PD Modification Application: PRS 24-0301

BOCC Land Use Meeting Date: July 9, 2024

Applicant: Bay Food Brokerage, Inc.

Case Reviewer: Michelle Heinrich, AICP

Existing

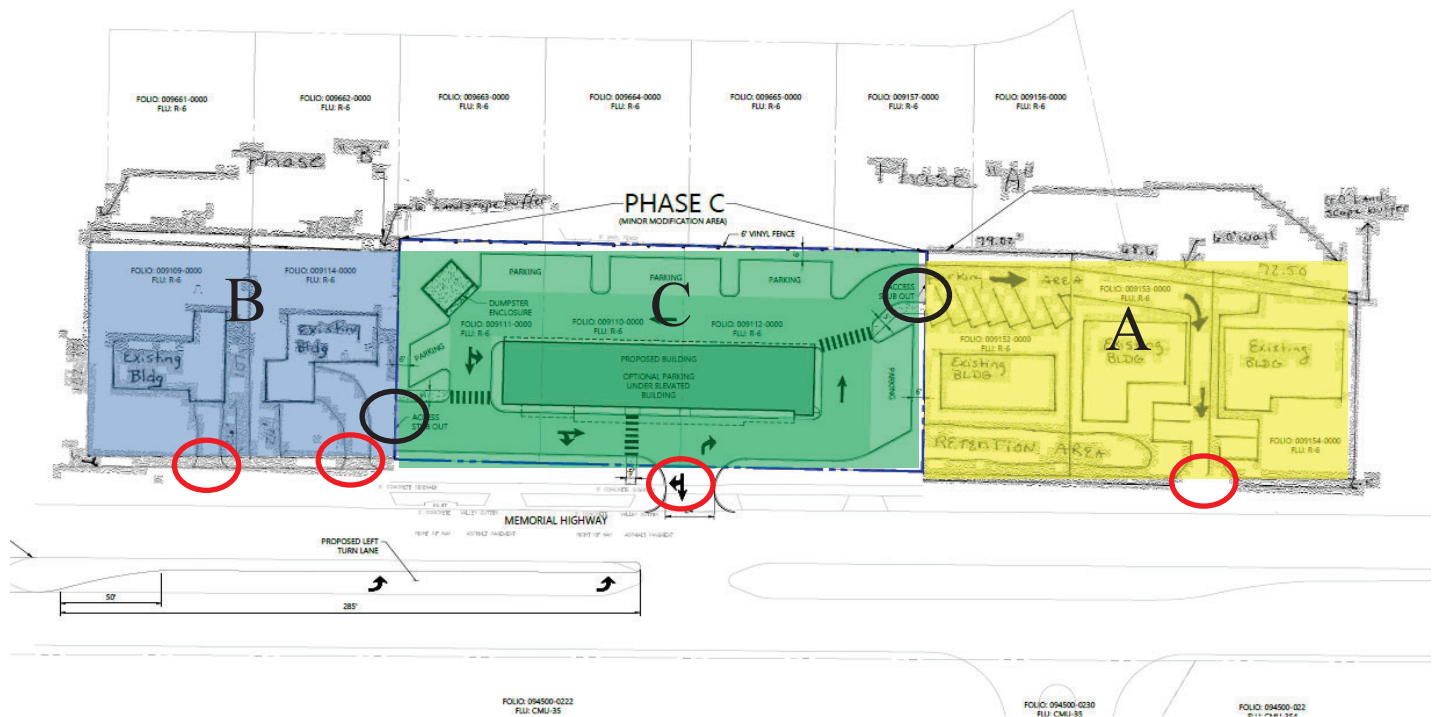
The area of modification is centrally located within the subject Planned Development. No additional uses or square footage beyond what was previously approved is requested. The maximum number of buildings on the site will decrease. Access changes are limited to Memorial Highway, which is reduced from six to four and access point to the northern residential is proposed. Cross access among the three phases will improve on-site circulation and Memorial Highway access.

Proposed

Primary Access 
Cross Access

8.1 Approved Site Plan (Full)

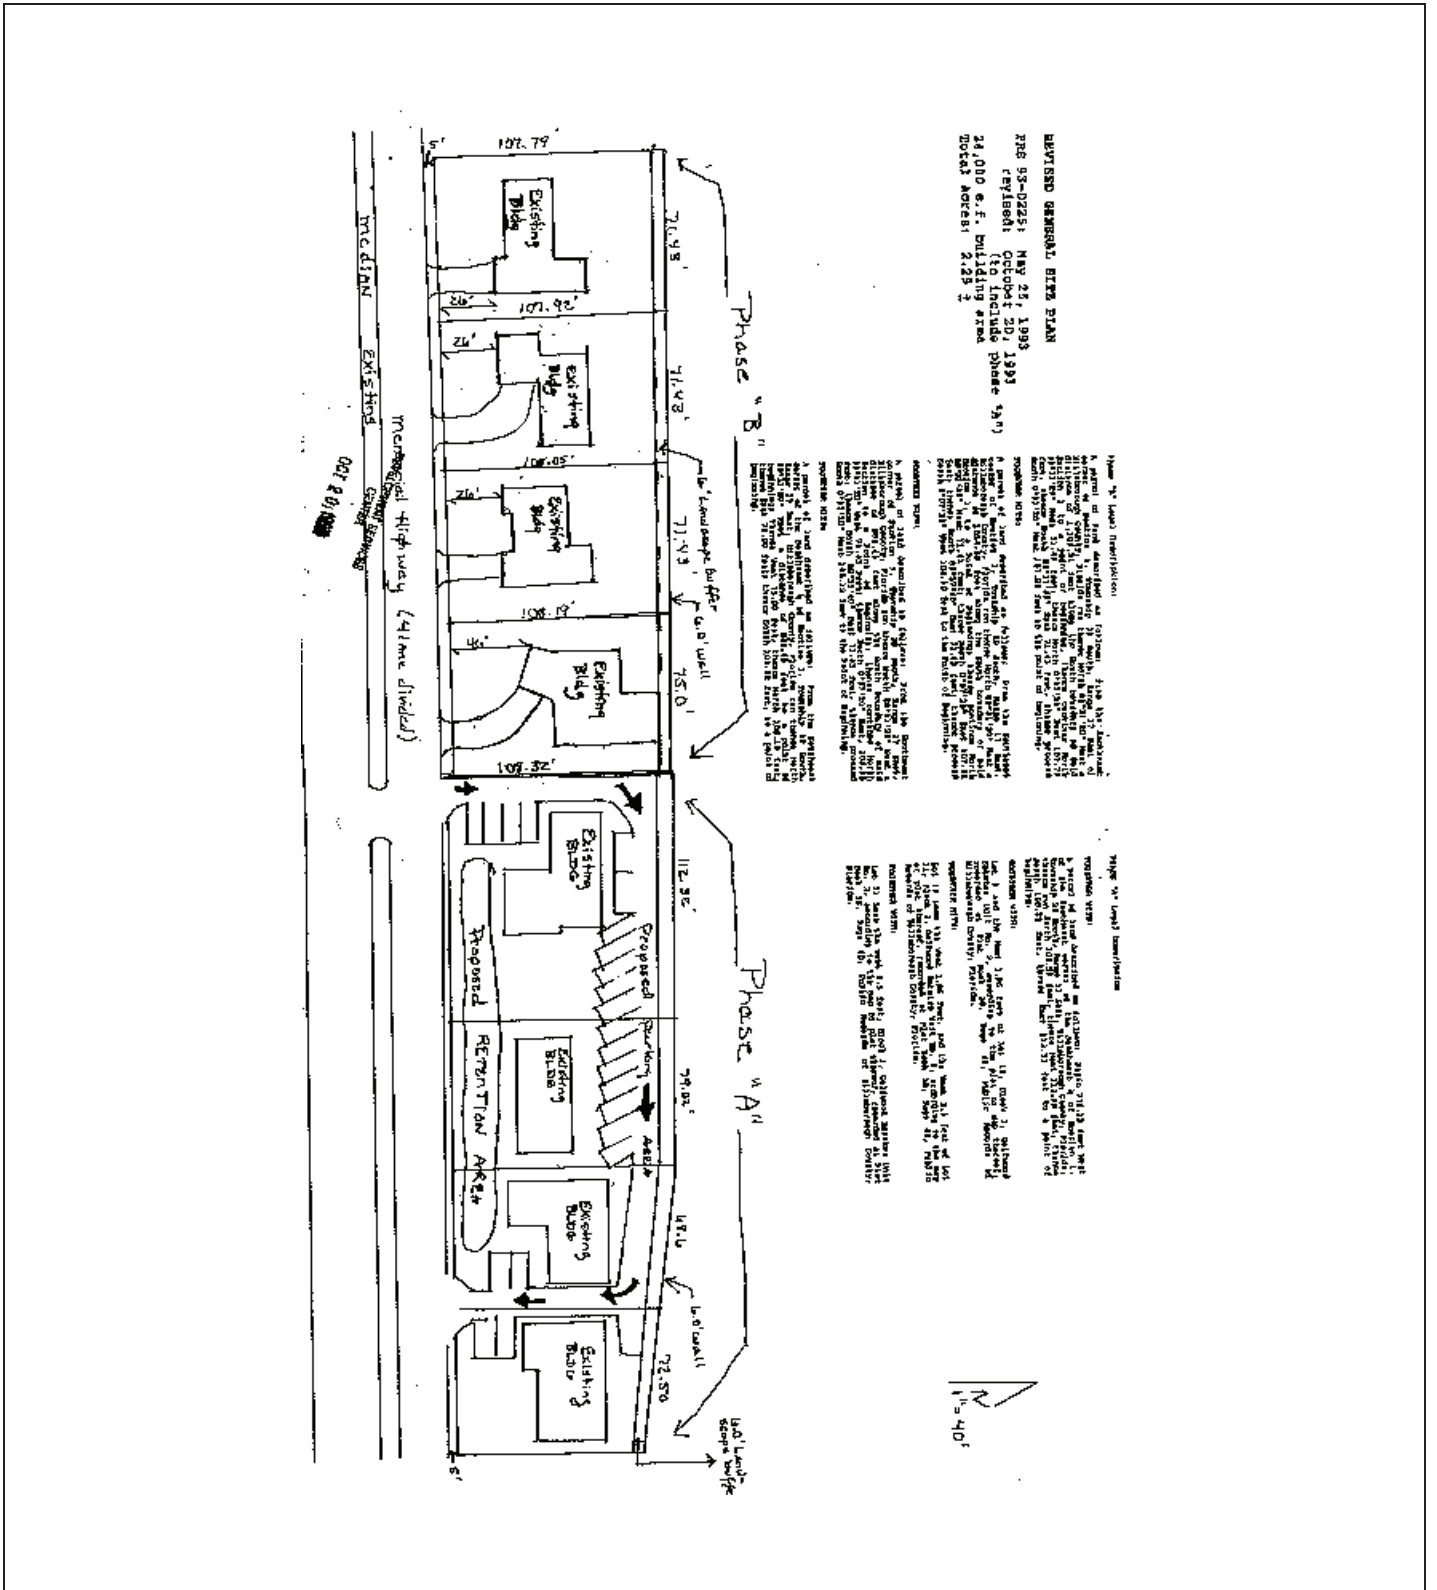
Approval of the request, subject to the conditions listed, is based on the revised general site plan submitted June 20, 2024.
